ADDENDUM #1

Project Name:
DOE ISD South Powerhouse Parking Lot Repair
DAS# 9462.00
RFB 946200-01
Addendum #1
Dated: January 05, 2026

Project No: 125-0595.10
Sheet C2

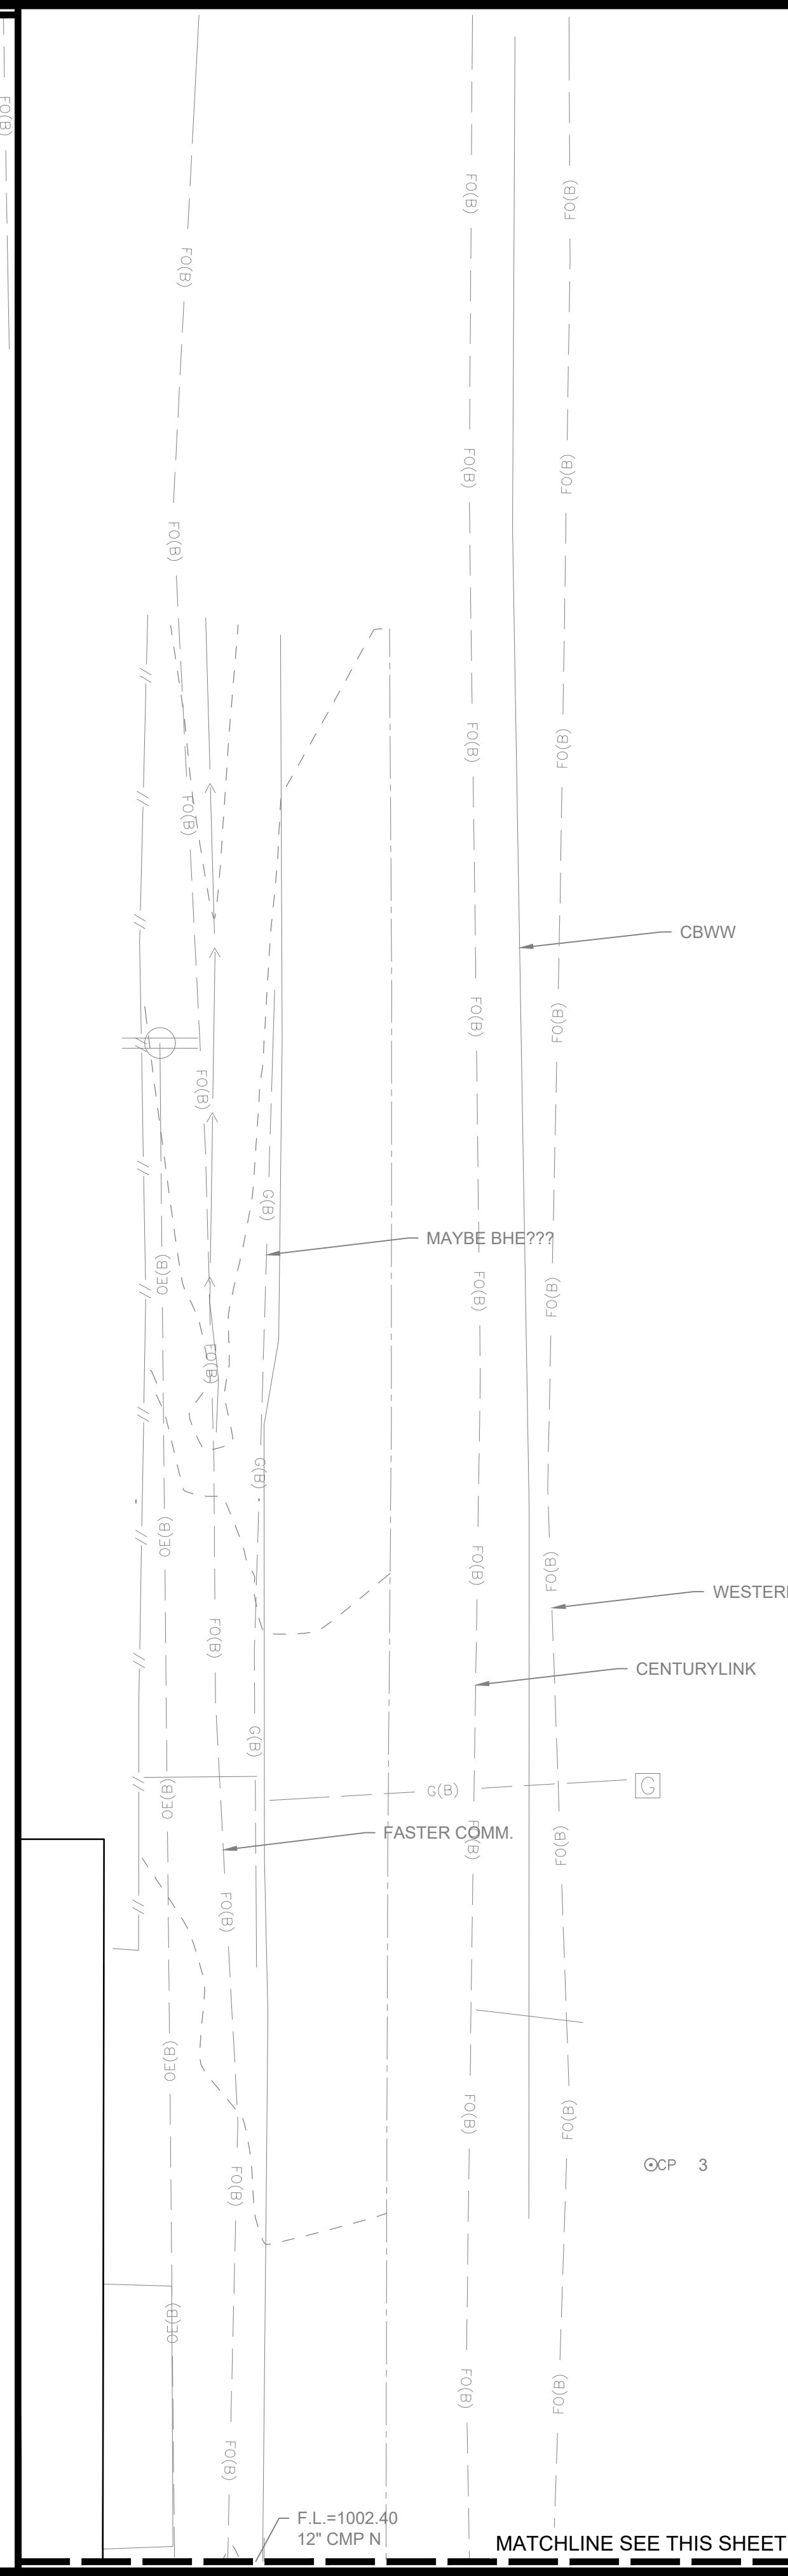
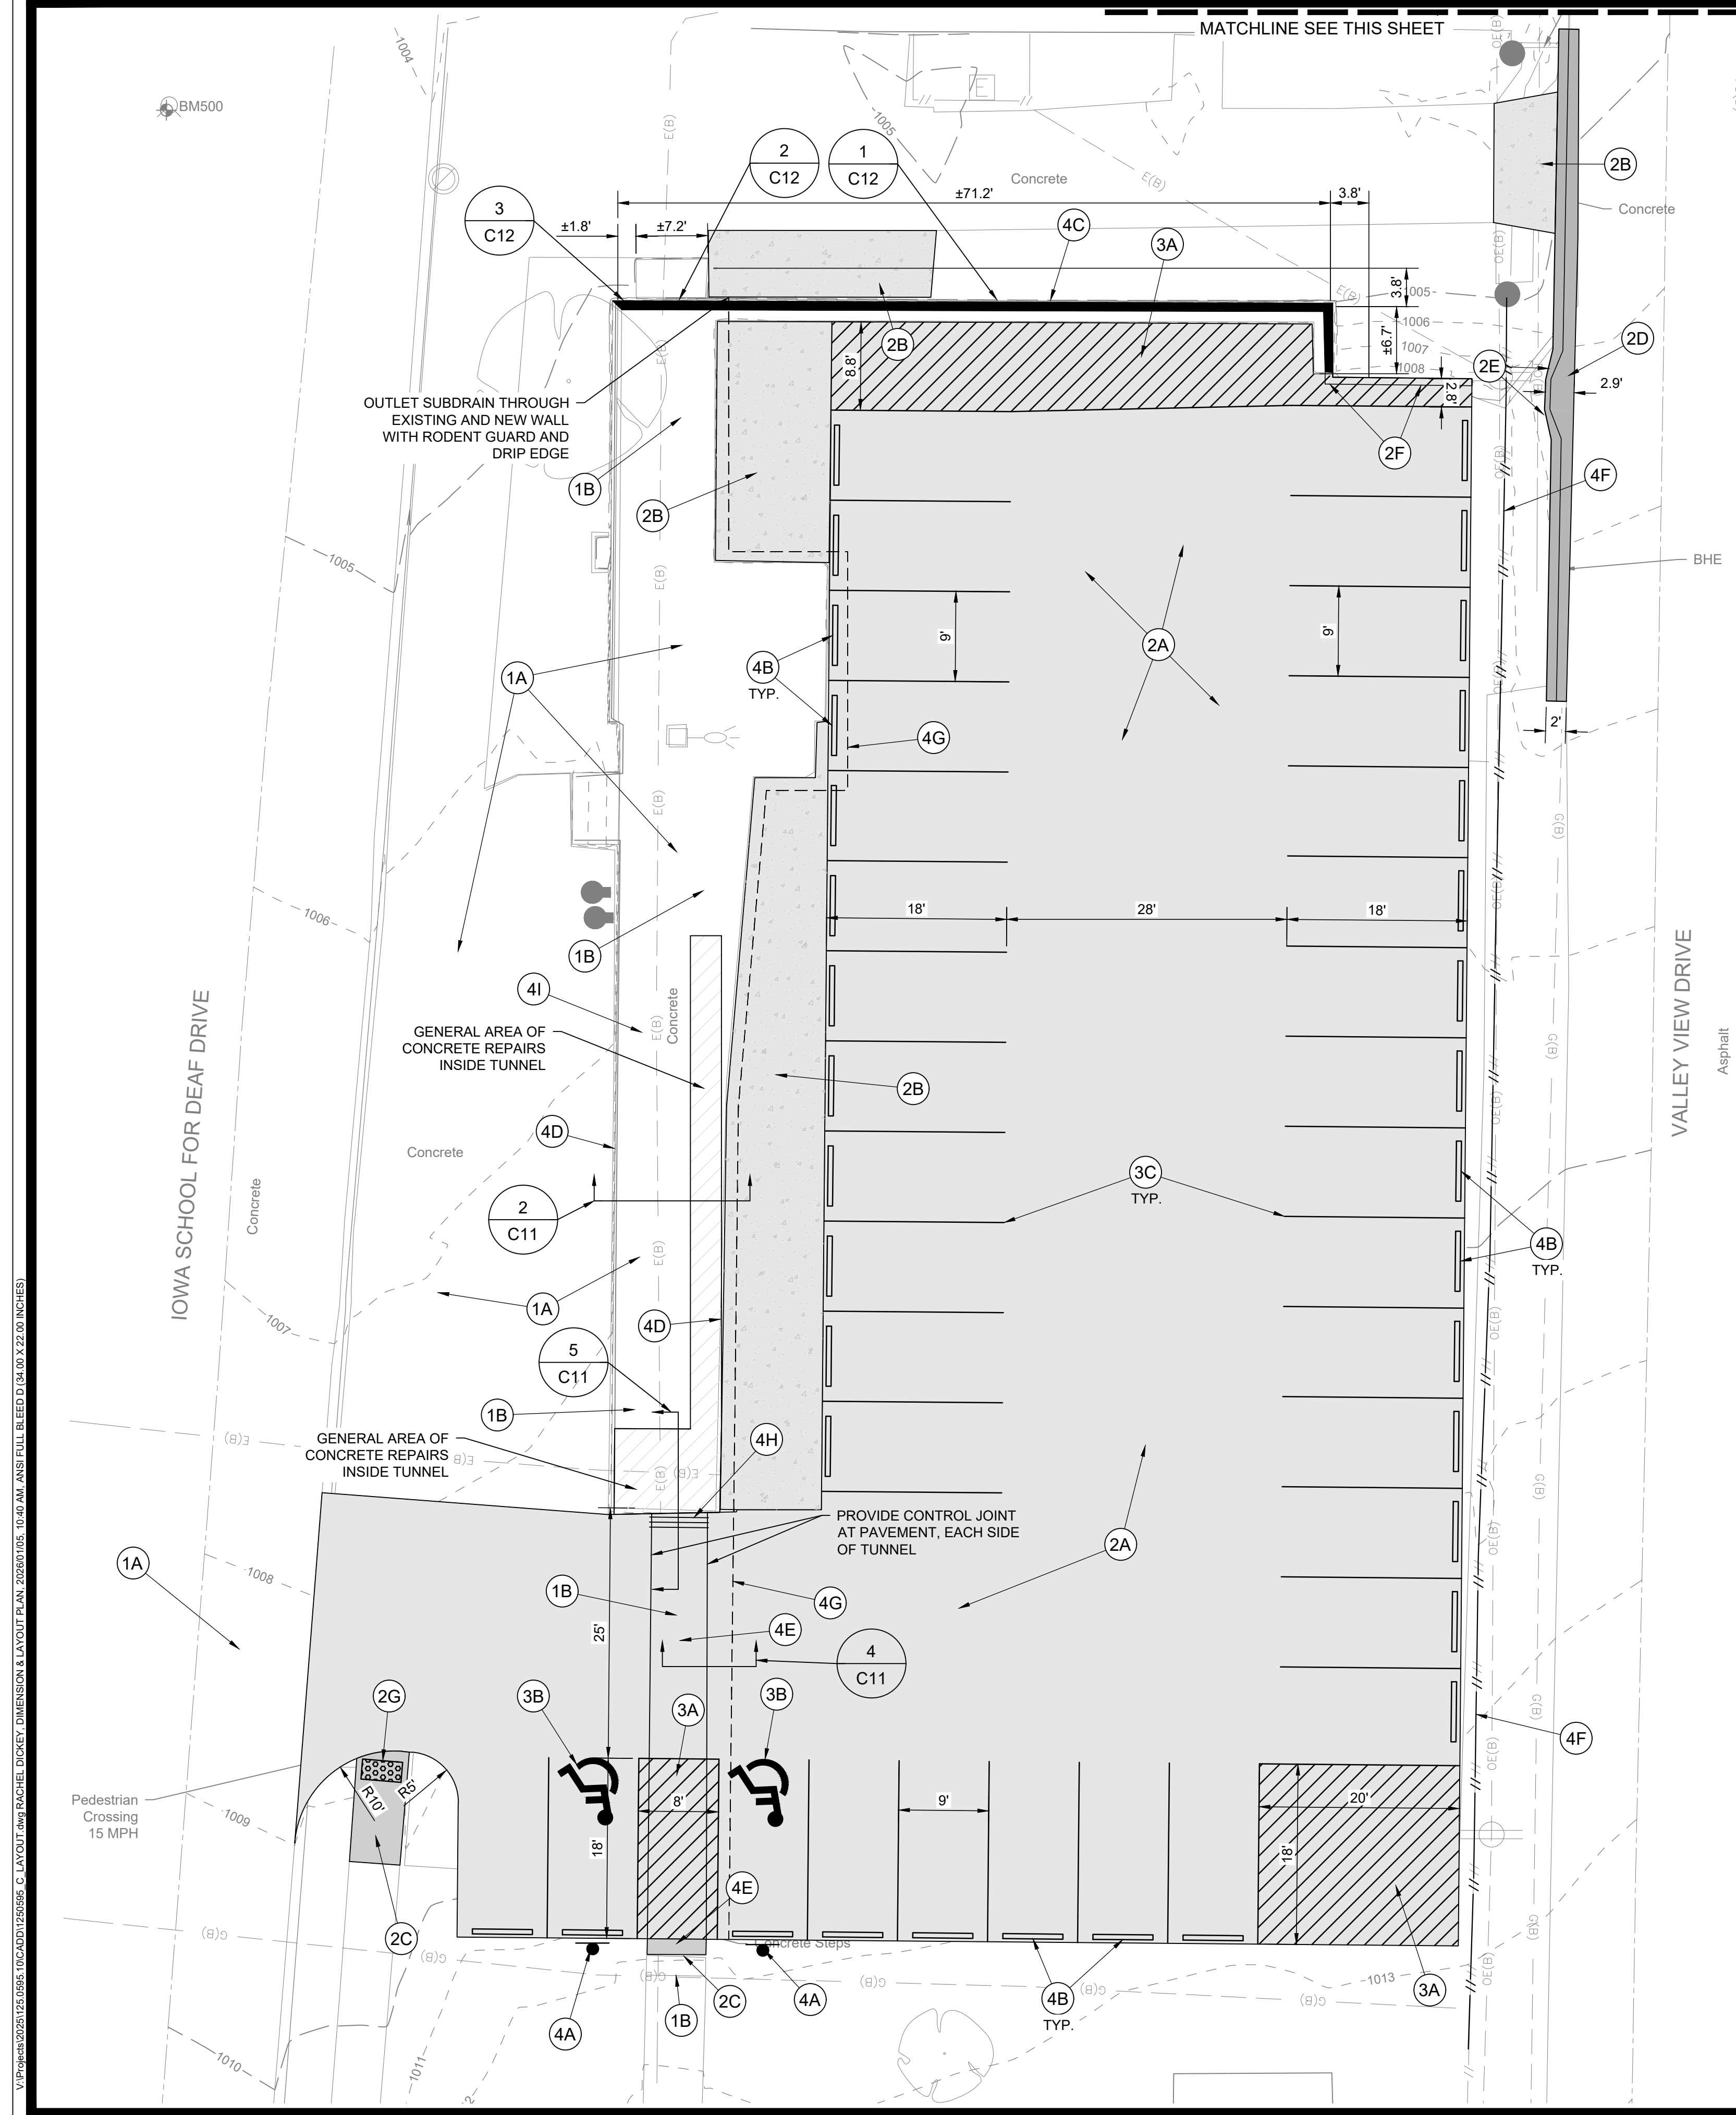
MARK	UPDATED BID ITEM NAME	REVISION	DATE	RMD
1			01-05-26
